## CLEVELAND NATIONAL FOREST POWER LINE REPLACEMENT PROJECTS

### MINOR PROJECT REFINEMENT REQUEST FORM

<b>Date Submitted:</b>	04-12-18	<b>Request #:</b>	017
<b>Date Approval Required:</b>	05-15-18	<b>Landowner:</b>	Various
<b>APN:</b>	XXX-XXX-XX, XXX-XXX-XX, XXX-XXX-XX, XXX-XXX-XX, XXX-XXX-XX, XXX-XXX-XX, XXX-XXX-XX, XXX-XXX-XX, XXX-XXX-XX, XXX-XXX-XX, XXX-XXX-XX, XXX-XXX-XX, XXX-XXX-XX, XXX-XXX-XX		
<b>Refinement from (check all that apply):</b>			
<input type="checkbox"/> Mitigation Measure	<input type="checkbox"/> APM	<input checked="" type="checkbox"/> Project Description	<input type="checkbox"/> Drawing <span style="margin-left: 20px;"><input type="checkbox"/> Other</span>
<b>Identify source (mitigation measure, project description, etc.):</b>			
<p>In April 2015, San Diego Gas &amp; Electric Company's (SDG&amp;E's) responses to Data Request #10 were submitted to the California Public Utilities Commission (CPUC). The responses included Attachment B.8 C157 Route Map for the Cleveland National Forest Power Line Replacement Projects (Project), which depicted approved staging and fly yards. Pages B-45 and B-46 of the Final Environmental Impact Report/Environmental Impact Stateme

Attachment C: Survey Area Map  
C157 Map 1 of 1

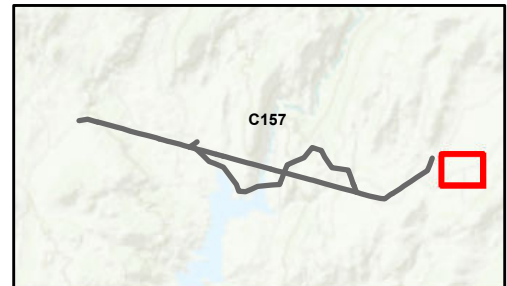
As depicted in Attachment B: Photographs and Attachment C: Survey Area Map, SDG&E proposes to add the Frye Staging and Fly Yard for use during reconstruction of C157. The yard will be approximately 1.14 acres. No grading will be required, but minor vegetation clearing will occur. The coast live oaks (*Quercus agrifolia*) located southeast of the yard will not be removed or impacted. The coast live oaks are shown in Attachment B: Photographs. Access to the yard will occur via Skye Valley Road, which is located north of the yard. The yard will be used for approximately six months. The activities associated with the utilization of the yard will be consistent with the Project description provided in the Final EIR/EIS.

The Frye Staging and Fly Yard is being requested to provide additional space for helicopter activities and construction and materials storage on the eastern portion of C157, which has limited ground access for equipment and lacks an approved staging and fly yard that is large enough to facilitate construction.

**Attachment D:  
Poles Exceeding the Maximum Height  
C157 Map 1 of 3**

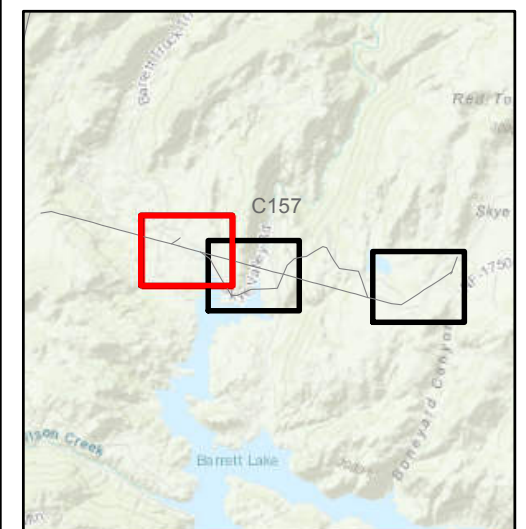
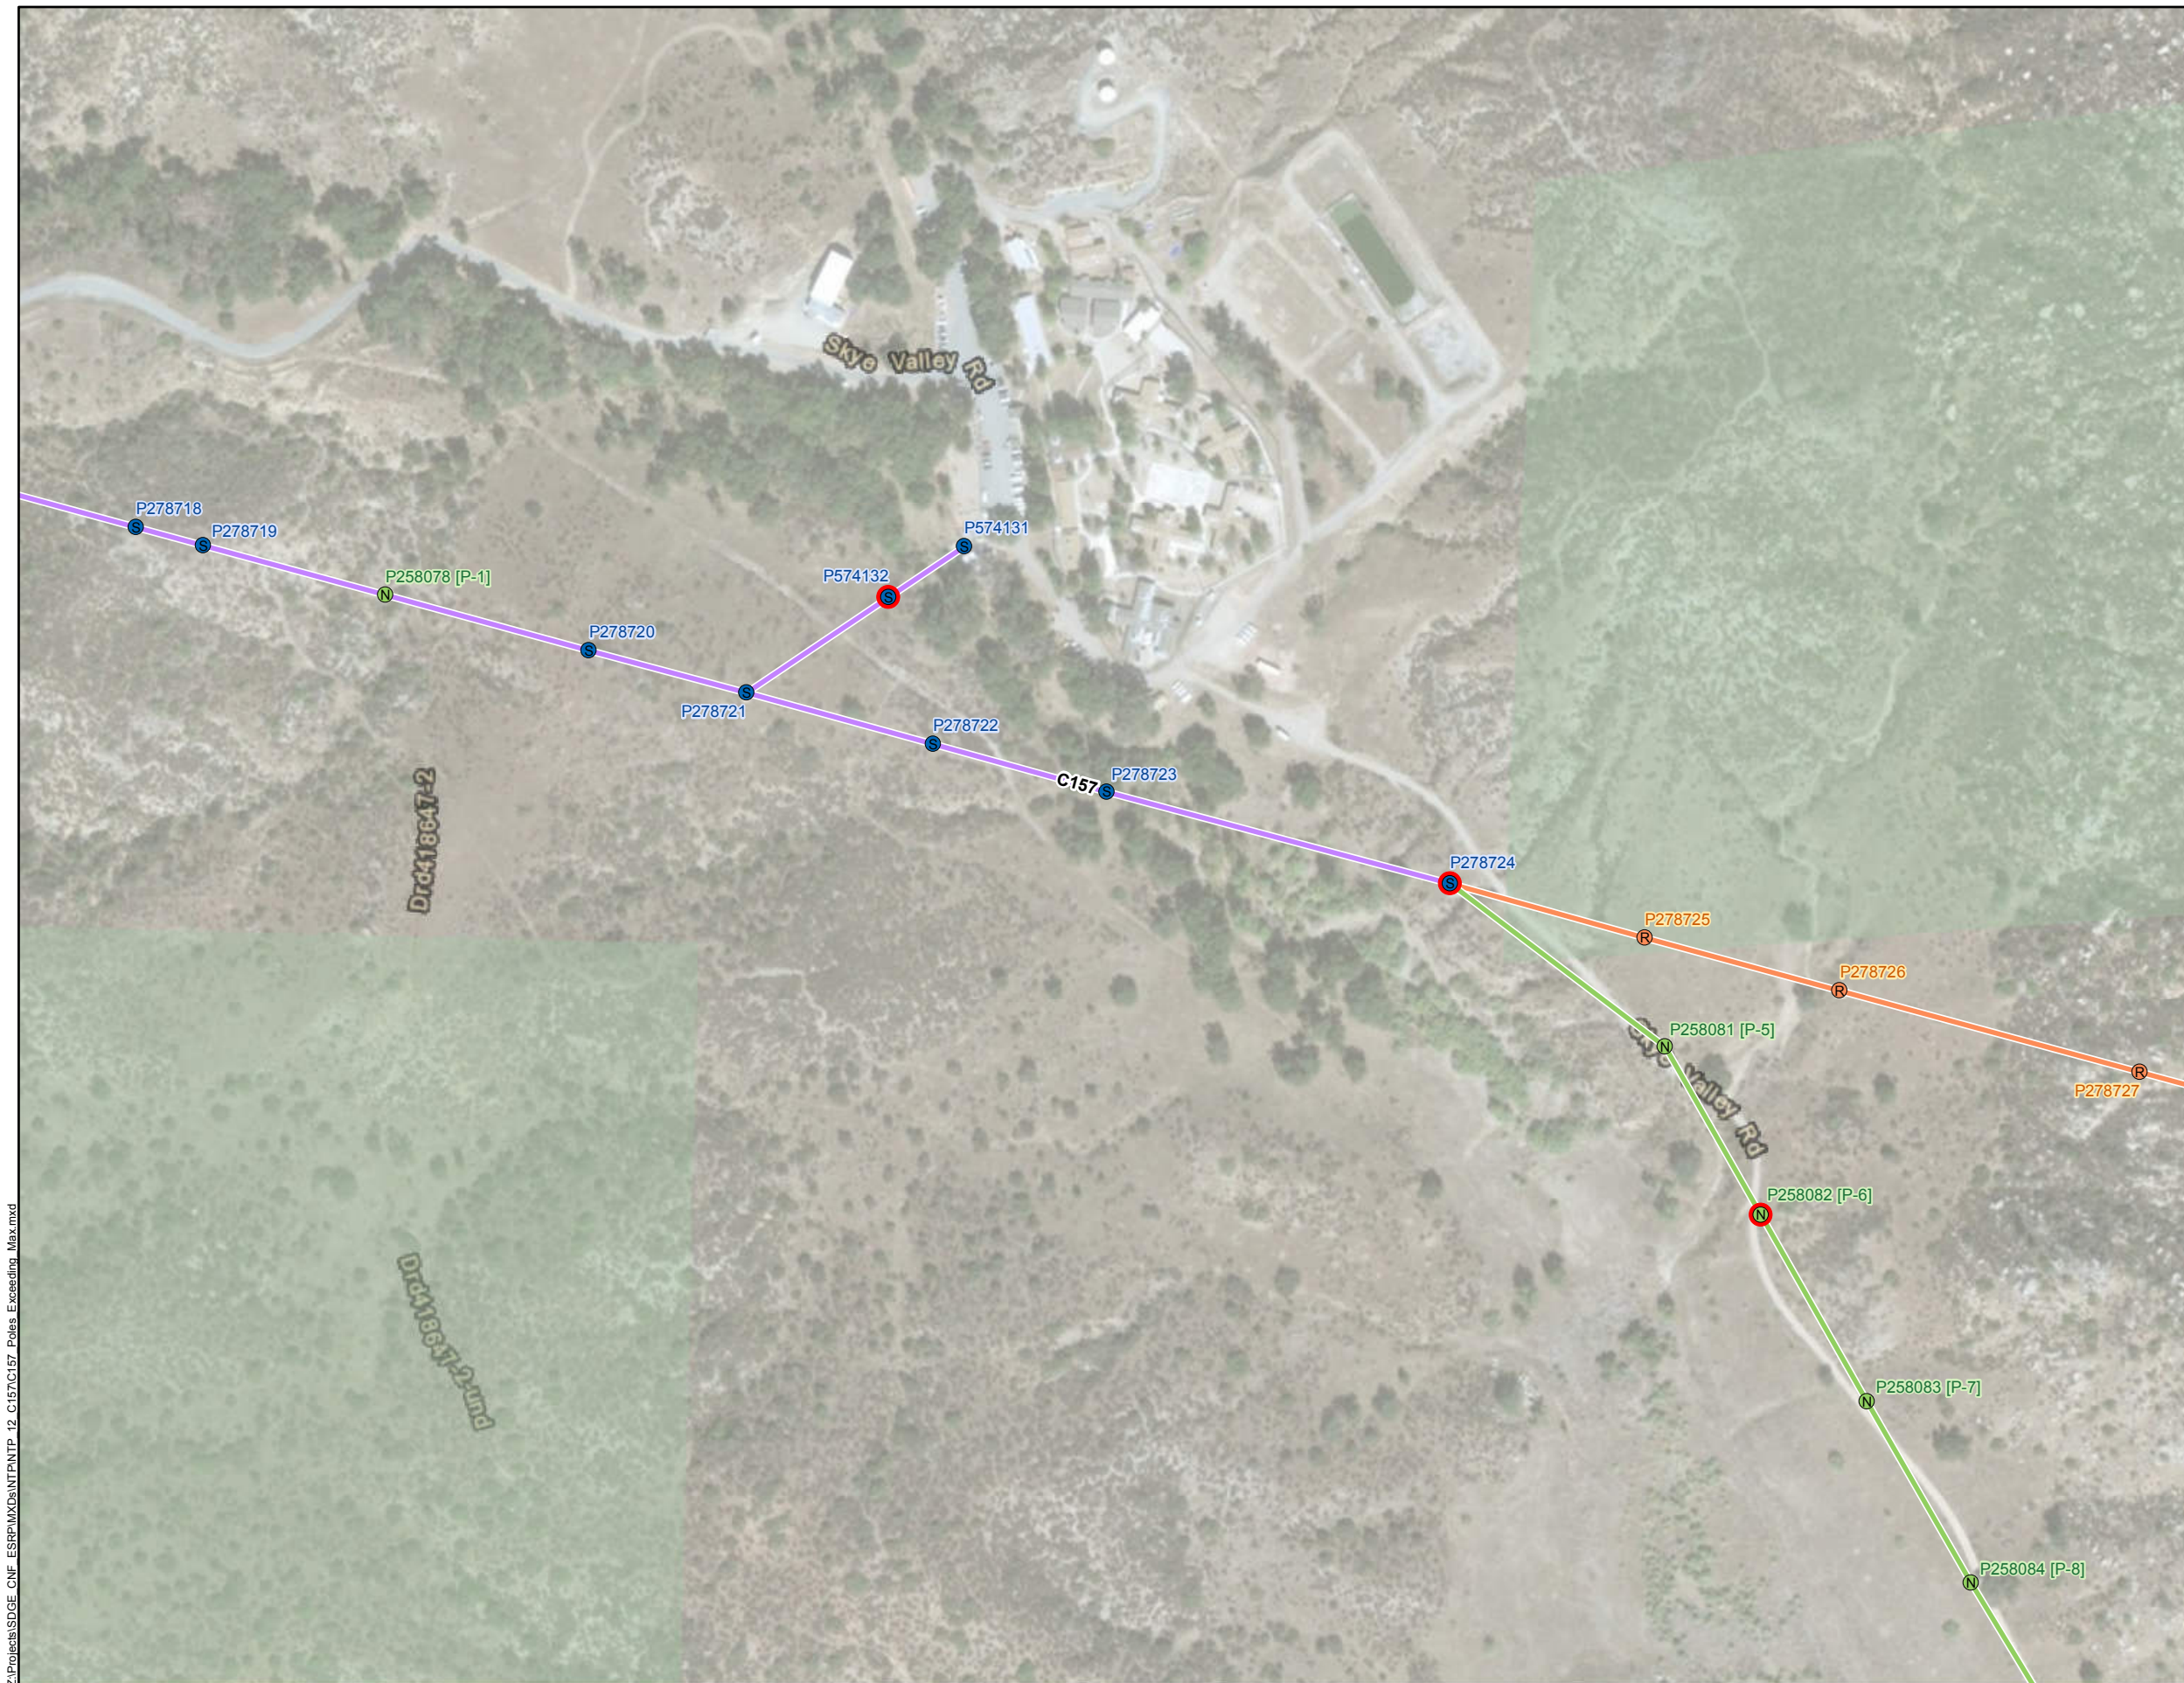
As shown in Attachment D: Poles Exceeding the Maximum Height and listed in Table 1: Poles Exceeding the Maximum Height, there are 13 poles that will exceed the maximum height described in the Final EIR/EIS by six inches to six feet. Because just the heights of the poles are changing, the poles are only analyzed in the Visual Resources section of Attachment A: Minor Project Refinement Request Screening Form.

- Poles P278724, P258082, P258086, P258087, P258092, P258093, P258094, P278743, and P476799 were increased slightly in height to maintain the minimum required clearances for power lines and communications facilities (i.e., AT&T) when crossing roads in rural areas.
- Poles P278750 and P574132 were increased slightly in height to maintain the required ground and wire-to-wire clearances for power lines. These poles also include adequate spacing for necessary electrical equipment.
- Poles P258089 and P258090 were increased slightly in height to provide additional loading capacity for necessary aerial marker balls.
